SUNDRY NOTICES AND REPORTS ON WELLS

Arboles 20A # 10

Energen Resources would like to change the bottom-hole location of the subject well to the new location plotted on the attached C-102.

WELL LOCATION AND ACREAGE DEDICATION PLAT

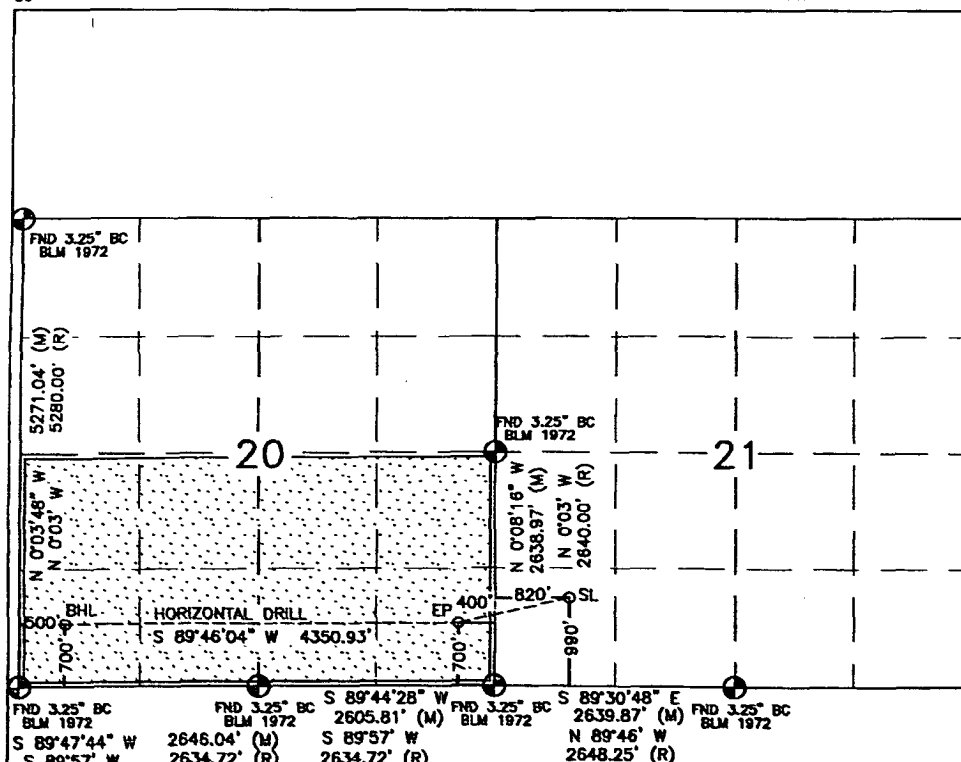
From: 1,000' FSL, 2,500' FEL Sec. 20, T32N, R04W, (O)

TO: 700' FSL, 500' ~~FEL~~ FWL Sec. 20, T32N, R04W, (M)

UL or lot no. M	Section 20	Township 32N	Range 4W	Lot Idn	Feet from the 700'	North/South line SOUTH	Feet from the 500'	East/West line WEST	County RIO ARRIBA
²³ Dedicated Acres 320.0 Acres - (S/2)			²⁴ Joint or Infill		²⁵ Consolidation Code		²⁶ Order No.
